101 Camley Street, Camden

Section 73 Minor Material Amendments Application to the London Borough of Camden

July 2018

This document has been produced to track the main amendments to the design between the Minor Material Amendments Application in December 2016 and the completion of the Stage 04 Detailed Design. These amendments have been necessary to implement in order to make the scheme technically viable.

NE Elevation. Scale 1:400 at A3.

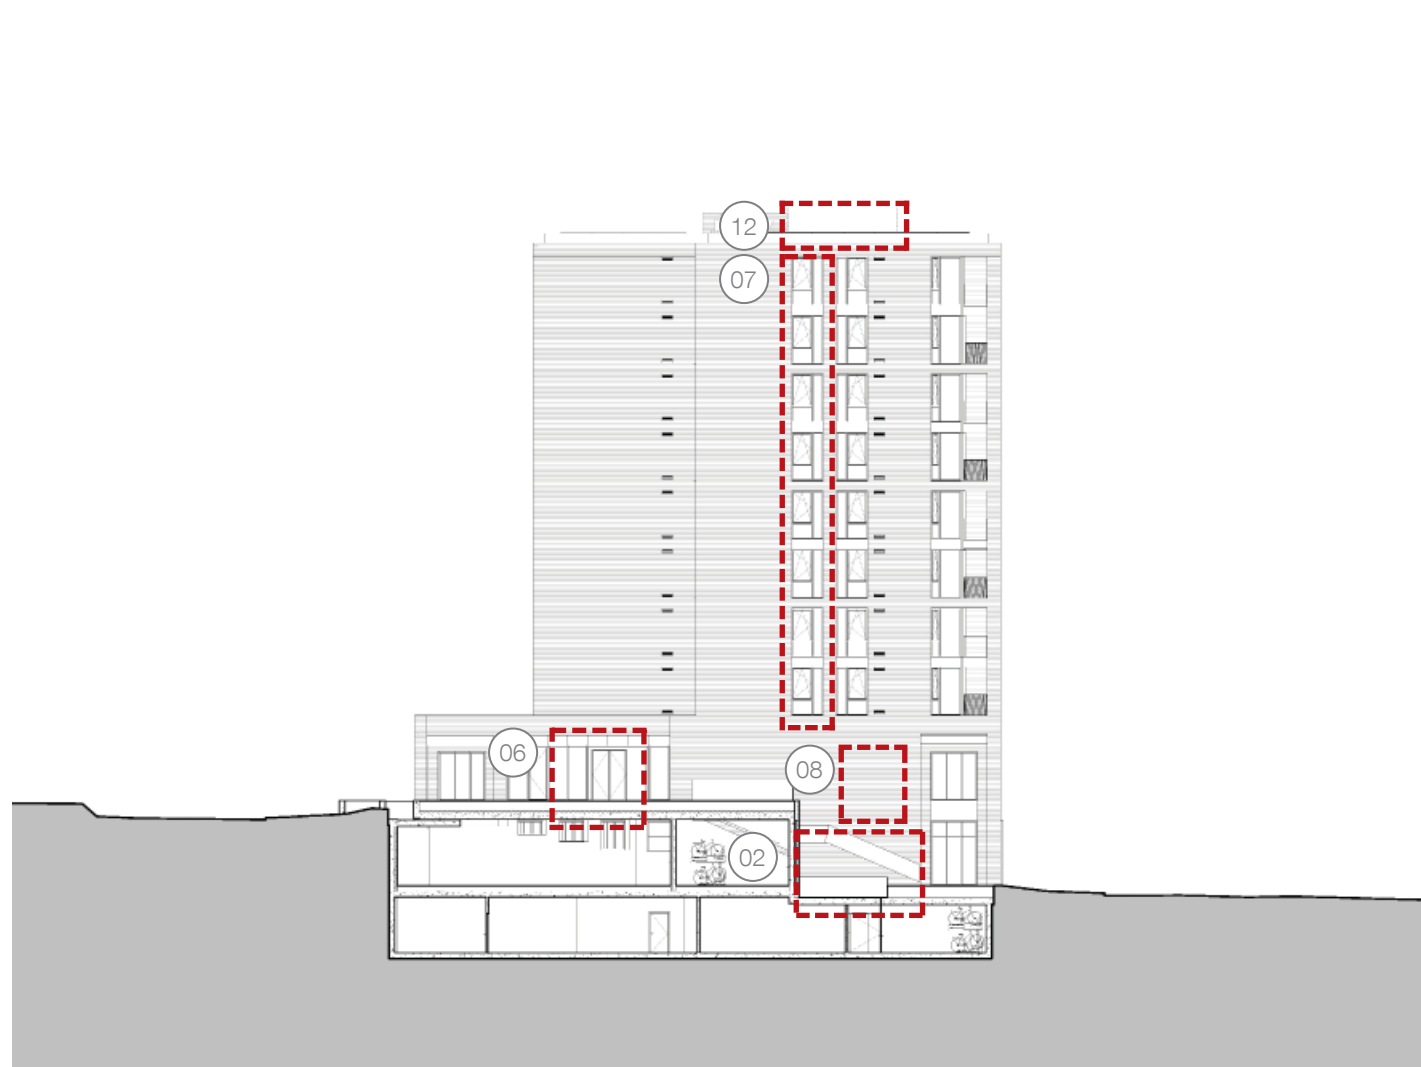
- Outline of affected areas.
- 03. Upper ground level spandrel panel depth.
- 05. Residential lobby glazing.
- 10. Terrace edge protection.
- 11. Parapet connection to glazed corners.
- 12. Acoustic enclosures at roof level.

NW Elevation North Block. Scale 1:400 at A3.

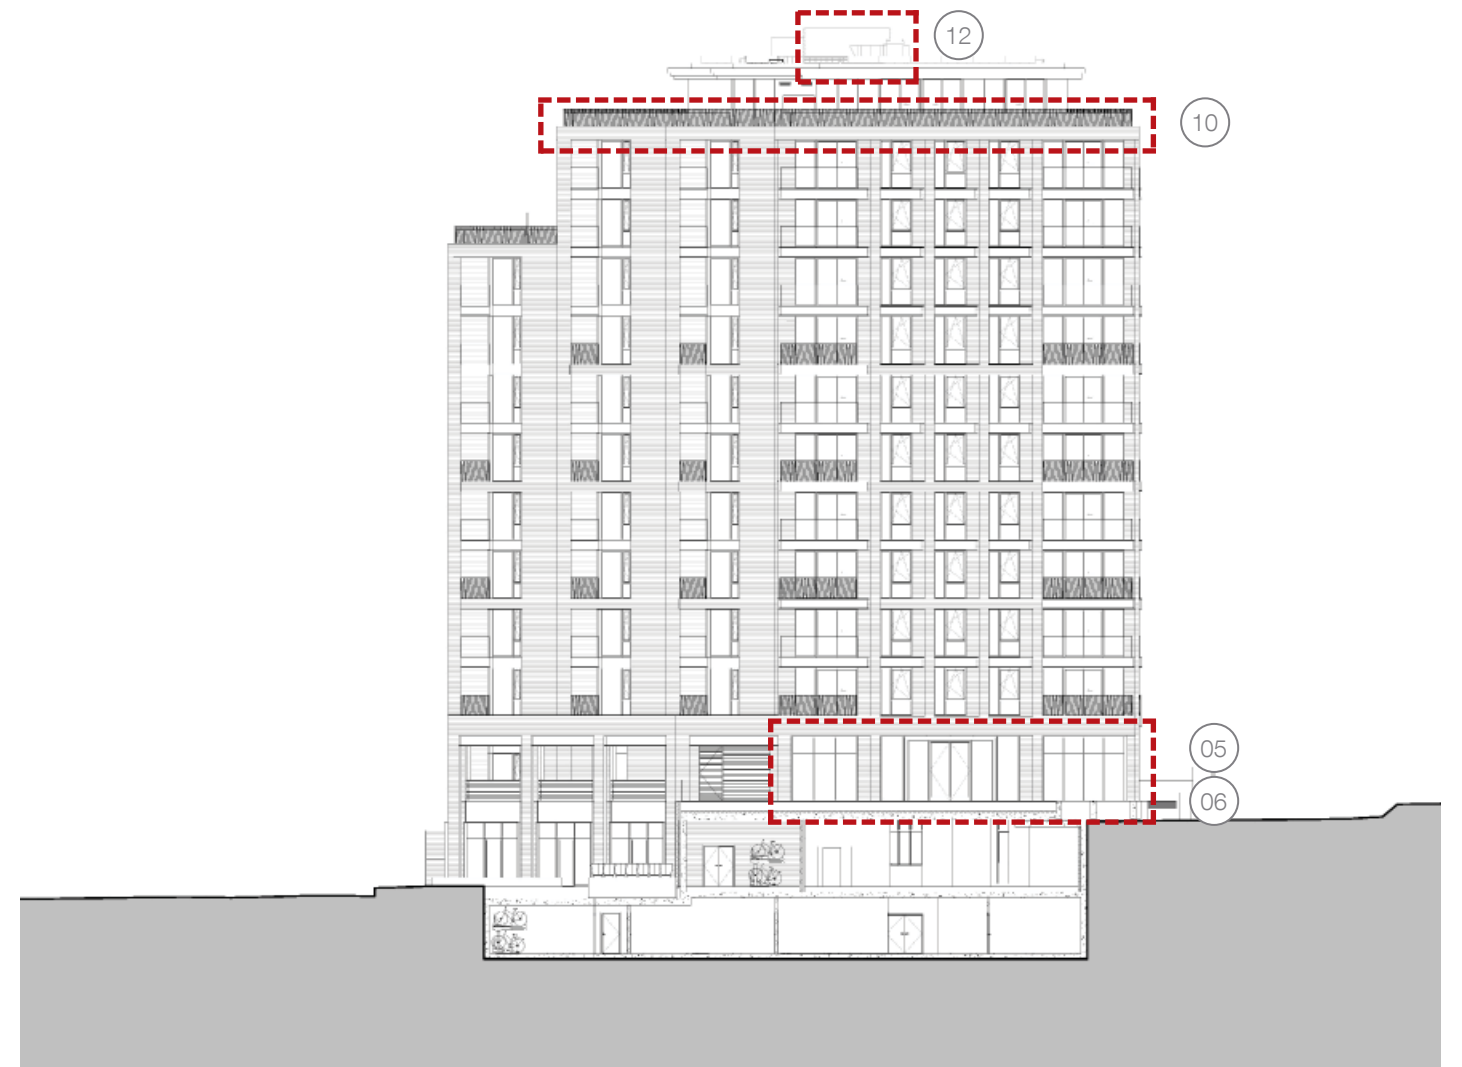
- Outline of affected areas.
- 11. Parapet connection to glazed corners.
- 12. Acoustic enclosures at roof level.

UPPER AND LOWER GROUND FLOOR

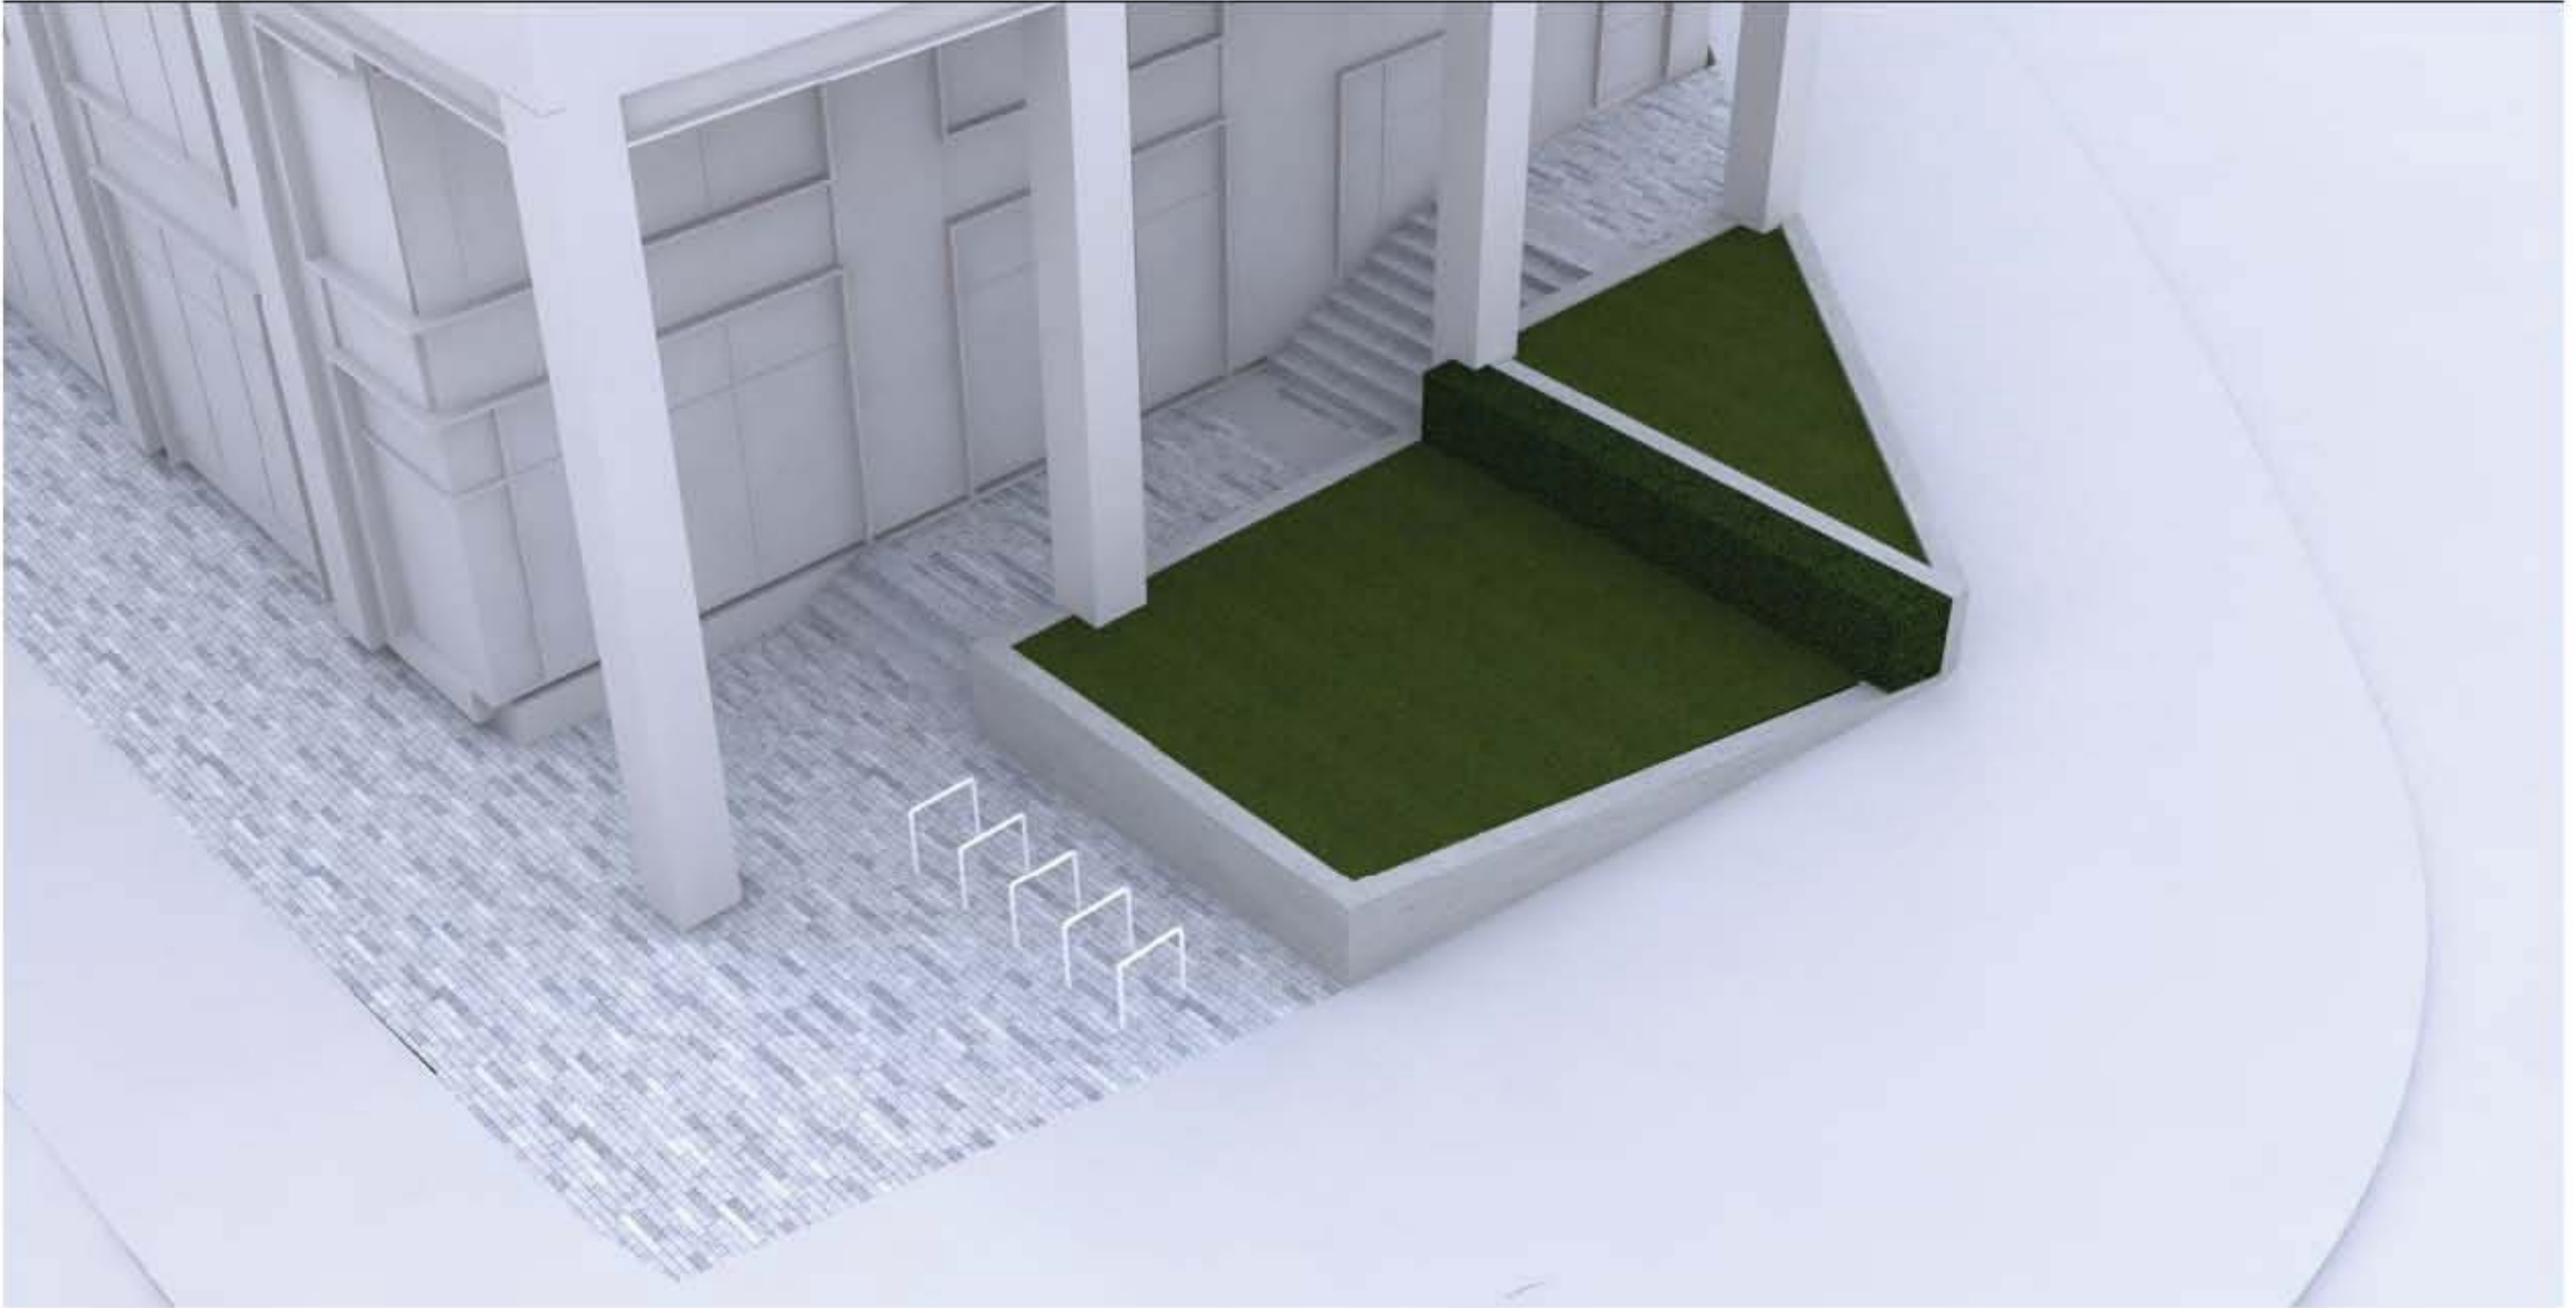
- 1 PLANTING AREAS HAVE BEEN INCREASED, CREATING GREEN GATEWAYS TO THE DEVELOPMENT WHILST RESOLVING LEVEL CHANGES.
- 2 STEPS FROM LOWER TO UPPER GROUND FLOOR HAVE BEEN MADE WIDER AND SEATING UNITS HAVE BEEN REMOVED TO RESPOND TO SHADED MICROCLIMATE.
- 3 TREE POSITION MOVED TO ACCOMMODATE ATTENUATION AND KEEP SPACES BETWEEN BUILDINGS CLEAR FOR PEDESTRIAN CIRCULATION.
- 4 SEATING TERRACES HAVE BEEN RATIONALISED, RESPONDING TO A SHADED MICROCLIMATE, NOW RELOCATED WITHIN A MORE COMFORTABLE SETTING AWAY FROM THE ROAD JUNCTION.
- 5 COMMUNAL GARDENS RESPOND TO INTERIOR DESIGN INCORPORATING FLEXIBLE SPACES CREATED BY AN ARRANGEMENT OF BESPOKE SCREENS AND RAISED PLANTERS.

MOVEMENT REMAINS CONSISTENT WITH PREVIOUS DESIGN ALLOWING ACCESS FROM CAMLEY ST AND GRANARY ST. RAMPS HAVE BEEN INTRODUCED PROVIDING DISABLED ACCESS FROM EXISTING PAVEMENT LEVELS TO PROPOSED LOWER AND UPPER GROUND.

GRANARY STREET ENTRANCE: STEPS TO UPPER GROUND FLOOR HAVE BEEN WIDENED AND SEATING TERRACES REMOVED DUE TO SHADED MICROCLIMATE MAKING LIKELIHOOD OF PEOPLE SITTING HERE IMPROBABLE. RAMPED ACCESS AND STEPS INTRODUCED TO ACCOMMODATE LEVEL CHANGE BETWEEN EXISTING PAVEMENT LEVELS AND PROPOSED LOWER GROUND FLOOR.

CAMLEY STREET ENTRANCE: STEPPED ACCESS TO UPPER GROUND FLOOR. TO ACCOMMODATE LEVEL CHANGE BETWEEN THE EXISTING PAVEMENT AND PROPOSED UPPER GROUND FLOOR, RAMPED ACCESS HAS BEEN INTRODUCED TO PROVIDE ROUTE FOR DISABLED USERS. PLANTING AREA HAS BEEN ENLARGED CREATING A SOFTER GATEWAY INTO THE DEVELOPMENT.

Scheme Submitted as part of Minor Material Amendment Application. Scale 1:400 at A3.

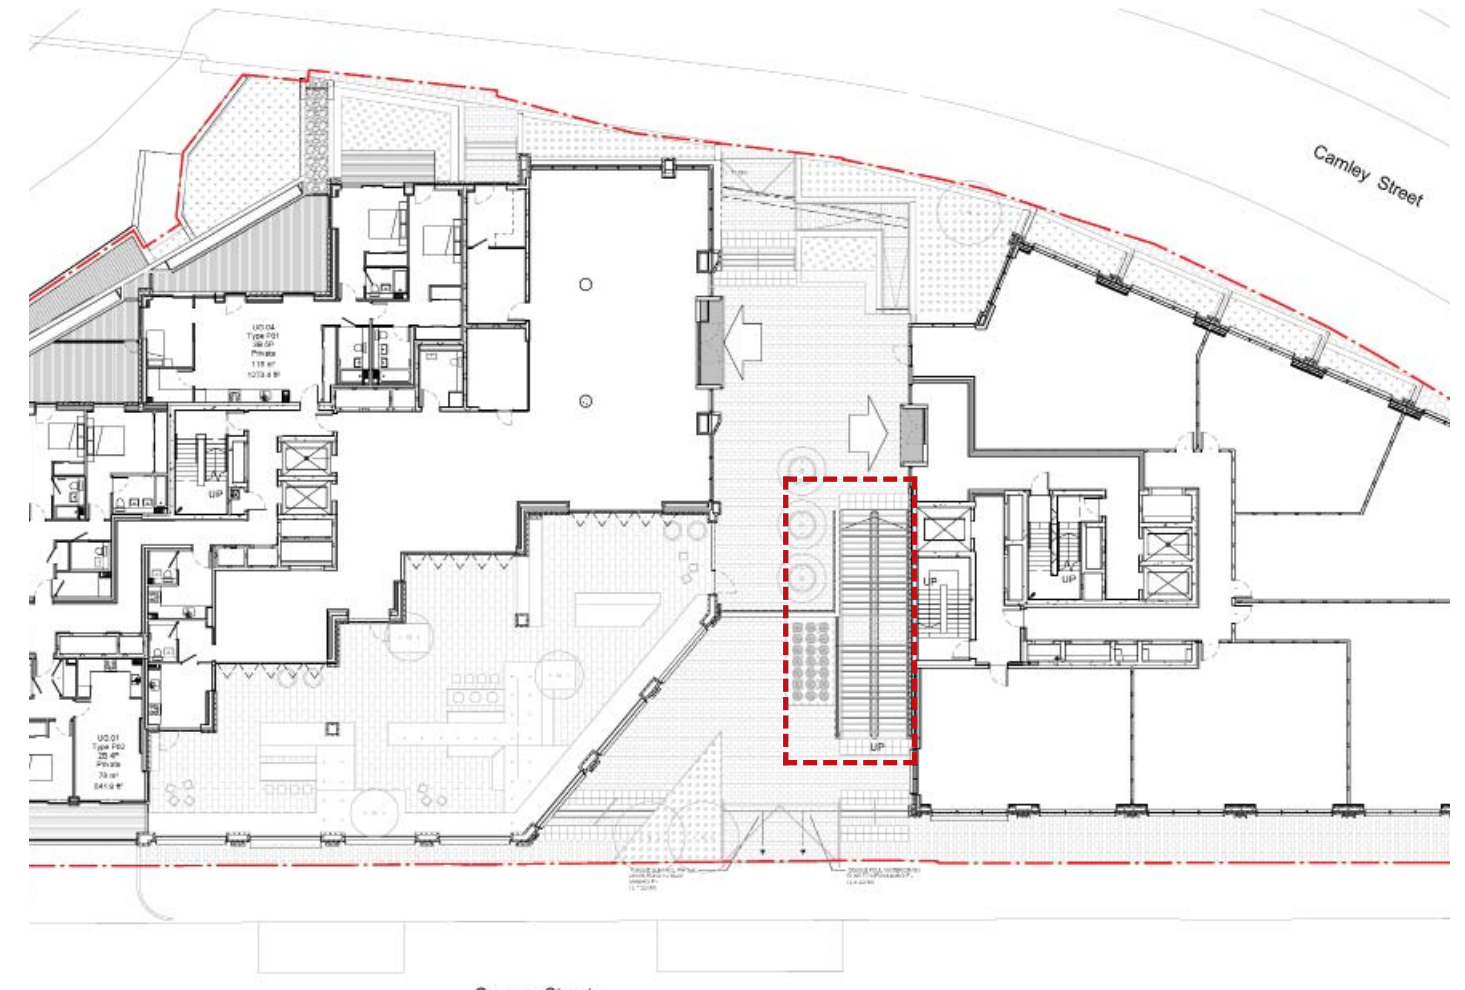
The revised staircase design has increased the width of the flights increased the permeability between Camley Street and Granary Street. The seating steps have been removed due to concerns over their suitability for rough sleeping, the stairs have also been realigned to remove the taper which also improves the buildability and simplifies the structural solution.

- To improve permeability of the scheme.
- To prevent rough sleeping.
- To improve structural practicalities.
